**Subject: Response to Portion of NRC Request for Additional Information
Letter No. 316 - Related to ESBWR Design Certification
Application – RAI Number 4.2-25 Supplement 2**

**Response to NRC Request for
Additional Information Letter No. 316
Related to ESBWR Design Certification Application
RAI Number 4.2-25 S02**

ESBWR Marathon control blade capsule impact test

Figure 1: Capsule Drop Test Apparatus
(Not to Scale)

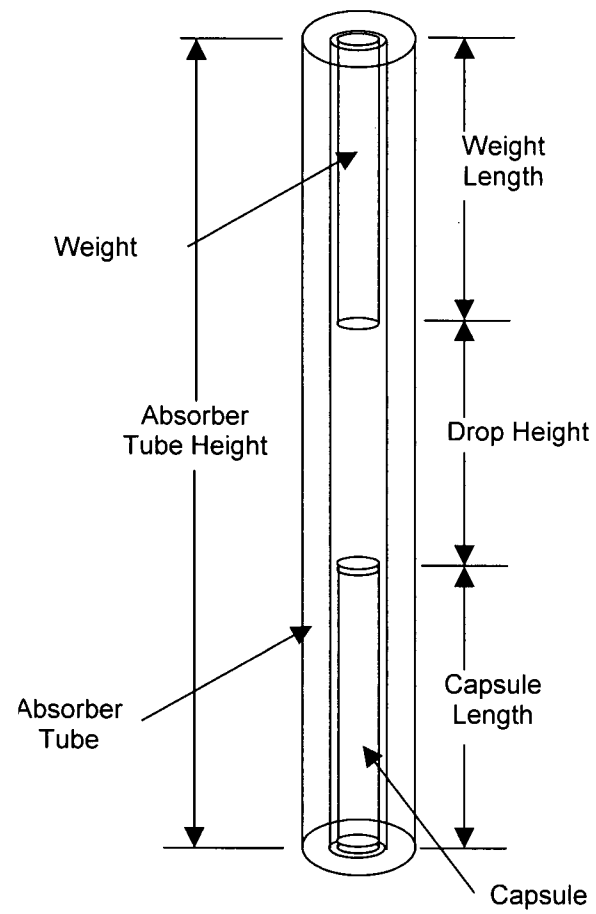
In response to RAI 4.2-25, Supplement 1, GEH performed an impact test on the ESBWR Marathon control blade capsules under ESBWR control blade scram conditions; however, the results were not supplied as requested by the RAI. Please provide (1) a description of the test procedure including the acceptance criteria, and (2) results from the test.

The test configuration is shown in Figure 1. The test simulates the scram impact load by dropping a weight on top of a boron carbide capsule. The amount of weight, and the drop height are sized to match the kinetic energy imparted to the capsule during the scram impact. The weight is set equal to that of the heaviest column of boron carbide capsules. The drop height is set such that the speed of the weight on impact with the capsule considers the maximum speed of the control rod during a failed buffer scram. This is [[]] for ESBWR.

The weight is dropped on each capsule a total of 30 times, simulating 30 lifetime scrams with a 100% failed control rod drive buffer. This is conservative, as the
